IEEE 802.16 Broadband Wireless Access Working Group < http://ieee802.org/16 >	
Title	MS context release indication
Date Submitted	2007-03-14
Source(s)	Hyunjeong Kang, Sungjin Lee, Hyoung Kyu Lim, Jungje Son, Panyuh Joo Samsung Electronics [mail to: hyunjeong.kang@samsung.com]
	Rakesh Taori Samsung Advanced Institute of Technology [mail to: rakesh.taori@samsung.com]
	Hyunjeong Lee Intel Corporation [mail to: Hyunjeong.hannah.lee@intel.com]
	Yuefeng Zhou, Masato Okuda Fujitsu [mail to: yuefeng.zhou@uk.fujitsu.com okuda@jp.fujitsu.com]
Re:	Call for technical proposals regarding IEEE project P802.16j
Abstract	This contribution proposes the scheme with which a serving MR-BS informs an old access RS of the release of MS context information.
Purpose	Discussion and Adoption in IEEE 802.16j
Notice	This document has been prepared to assist IEEE 802.16. It is offered as a basis for discussion and is not binding on the contributing individual(s) or organization(s). The material in this document is subject to change in form and content after further study. The contributor(s) reserve(s) the right to add, amend or withdraw material contained herein.

MS context release indication

Figure xx: Handover procedure involving RS with centralized HO control from MR-BS

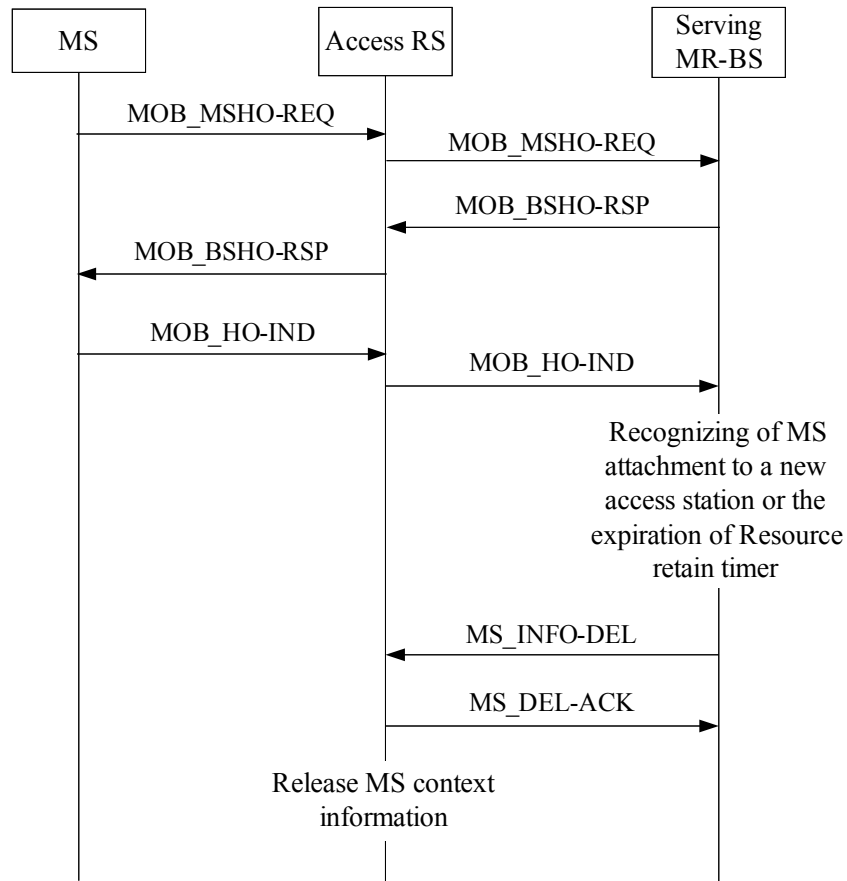
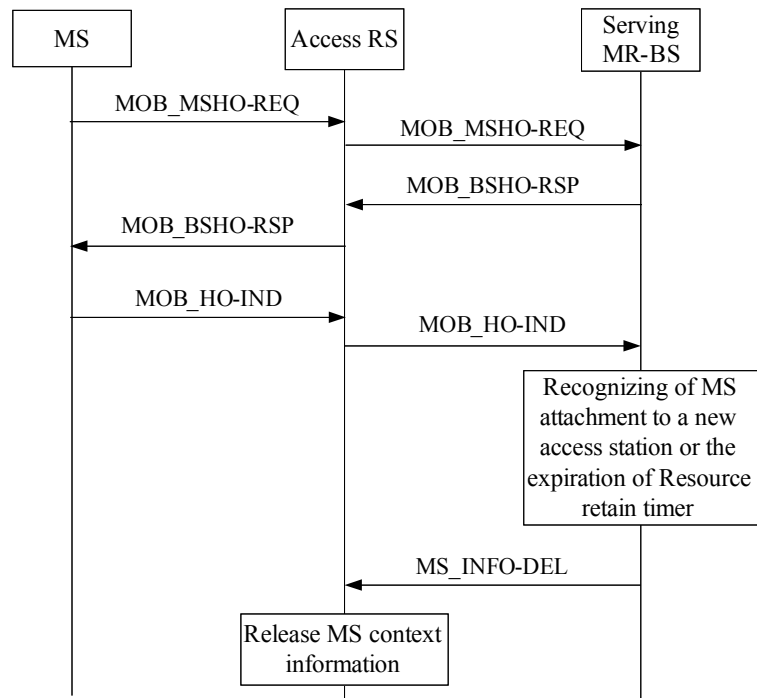
[Insert the followings at the end of section 6.3.22.5.1 in page 30]

If a serving MR-BS recognizes that MS attaches to a new access station or Resource retain timer expires, and the MS's old access station is an RS which is controlled by the MR-BS, the MR-BS may send the MS_INFO-DEL message to make the RS discard MS context information. Upon receiving the MS_INFO-DEL message, the RS shall transmit MS_DEL-ACK as a reply and remove the MS context information.
